# UNITED STATES PATENT AND TRADEMARK OFFICE

10/076,275

**Office Action Summary**

## DETAILED ACTION

*FIG. 3.*

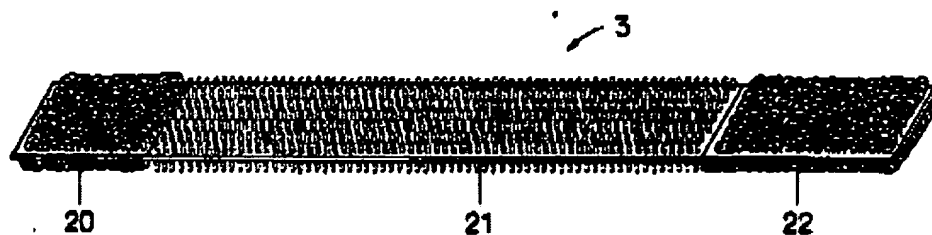
Hahn (figures 1-4d) teaches a folding tie 3 comprising three segments, two end segments 20, 22 with loop material on the opposite major faces and a central segment 21 with hook material on the opposite major faces connecting the two end segments 20, 22. Folding tie 3 is reproduced below from figure 3:

The description of the use of the tie is consistent with that shown in figures 4a and 4b wherein the cord 24 is placed at the intersection of segments 20 and 21 with the segment 20 folded over the cord so that the top surfaces of the two segments engage in the same manner as required for tie 1.

The difference is that while Hahn provides structure for folding and joining the three segments 20, 21, 22, the segments having the hook and loop material on opposite major faces are immediately adjacent each other so that the folding and joining structure is not clearly located between the segments.

FIG. 6

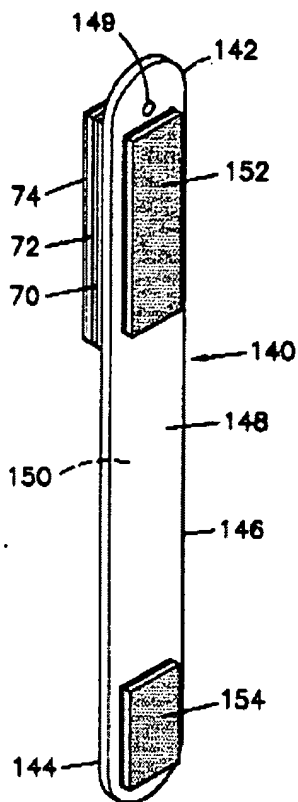
However, Polad (figures 6, 8, 9) teaches spacing the interlocking materials 152, 154 apart and that hinge grooves can be placed in the centered portion so as to form a narrowed hinge fold axis, an example of which is identified by reference numeral 54 in figure 9. Figures 6, 8, 9 and the descriptive material of figure 6 found in column 5, lines 7-37 are reproduced below:

Polad indicates that it is desirable to provide a fold axis defined by hinge grooves between spaced interlocking segments as allowing easier bending at a preferred area between the spaced interlocking segments.

FIG. 9

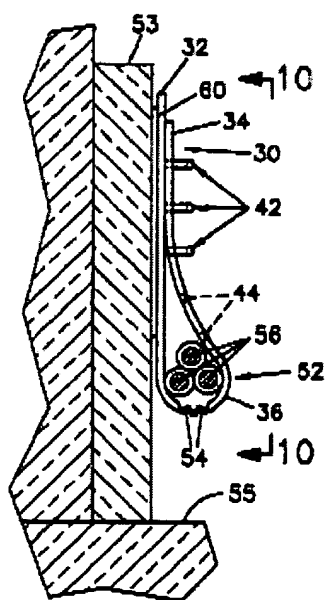
In regard to claims 23 and 24, while Hahn suggests using canvass or nylon strapping as a backing to the hook and loop material to add strength, Polad clearly suggests a continuous flexible support element 146 common to adjacent interlocking segments wherein hinge grooves are formed therein thereby creating a narrowed spanning-element at the location of the grooves.
